SUBJECT: SPOA3T-AP-EH1 Installation**DATE: 18.08.2021****BULLETIN No. B000037****FAO: Installation Engineers**

This Bulletin is to bring to your attention and to specify the dimensions for the SPOA3T-AP-EH1 installation.

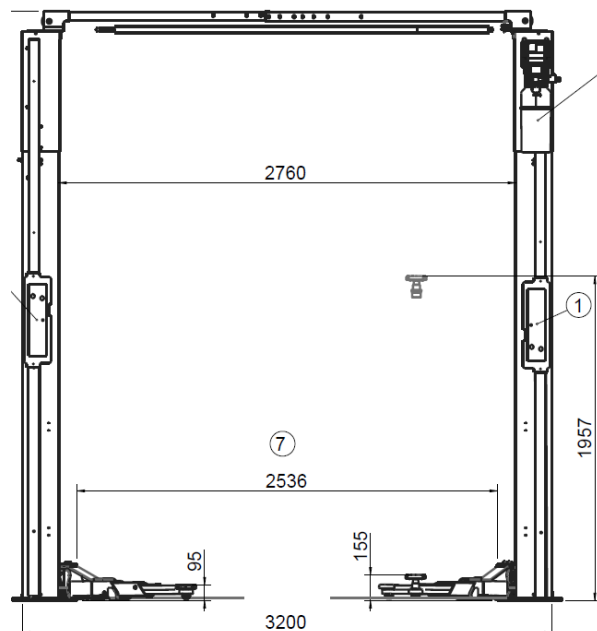
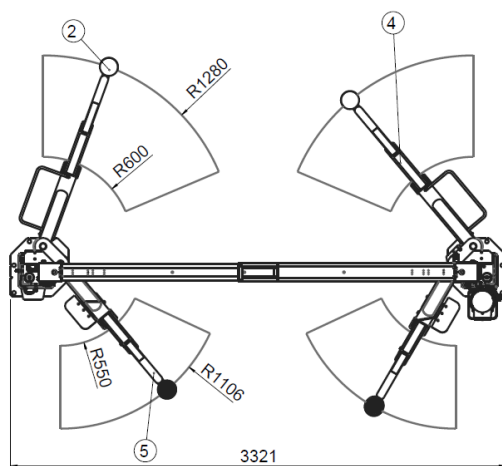
1, Page 14 figs.6 Detail (A) column width dimensions. This has the incorrect overall width dimension.

2, Page 26 the SPOA3T-AP Specification. This has the incorrect overall height and overall width dimensions.

The correct overall height is 3865mm.

The correct overall width is 3321mm

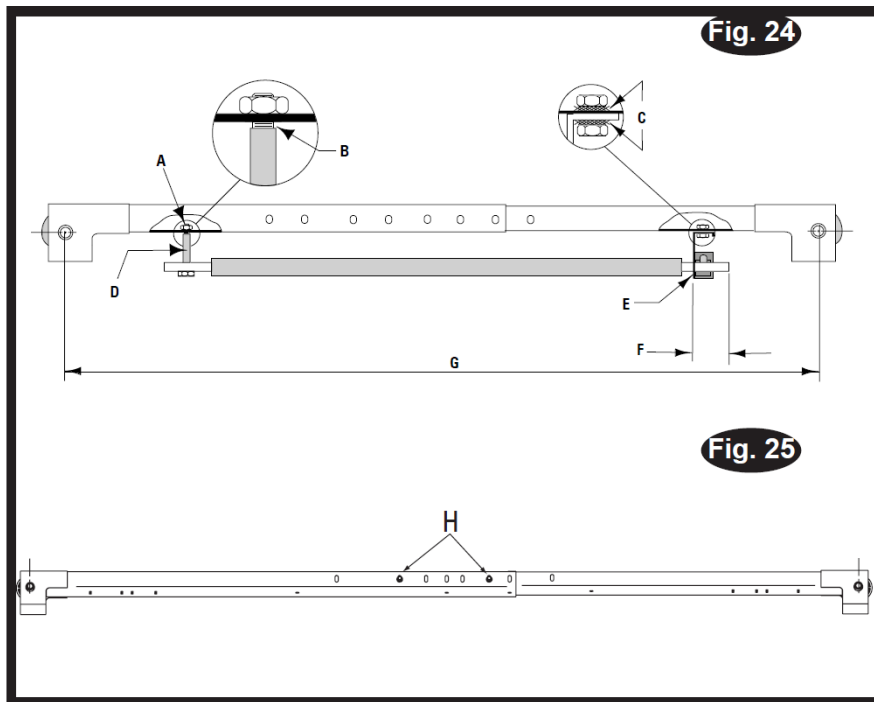
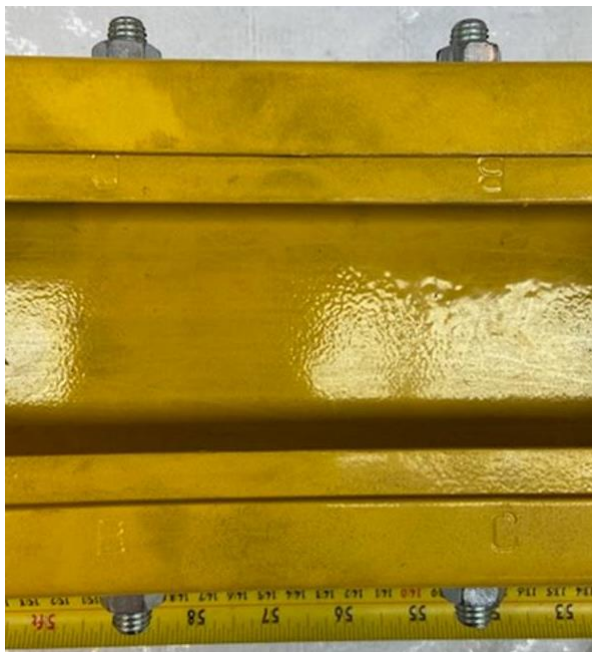
3, Page 43 Fig. 24/25 Detail (G) AP dimension. This AP specification for overhead assembly dimension is incorrect.

The correct (G) dimension for the overhead assembly is 2880mm

B & C will line up with each other at dimension of 2880mm.
